Office Action Summary	Application No. 10/573,276	Applicant(s) MICHELS ET AL.	
	Examiner AMENE S. BAYOU	Art Unit 3746

DETAILED ACTION

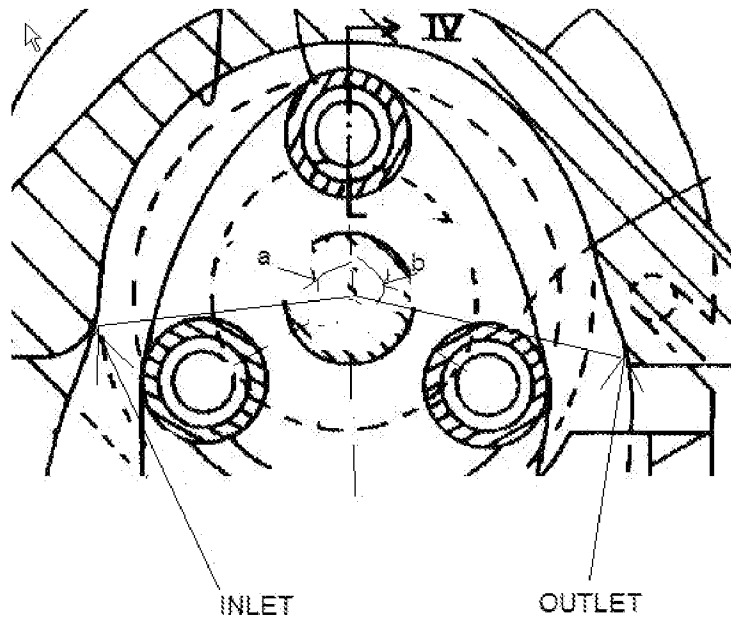
and the inlet portion (see figure below) is offset around the axis of rotation of the rotor (22) with regard to the outlet portion (see figure below) by 210.degree to 270.degree, in figure 3.

angle a +angle b is greater than 210 degree

27. In regards to claim 14 applicant, in page 4 paragraph 2 argued that the actual inlet and the outlet regions -i.e. the locations at which the tubing is actually squeezed by the rollers are offset by about 200 or less. Examiner respectfully disagrees. Claim 14 which was dependent on claim 1 (now incorporated to claim 1) and claim 1 doesn't specifically define that the inlet and outlet region are the locations at which the tubing is actually squeezed by the rollers. As clearly shown in the annotated drawing the angle is 210 degree or more.
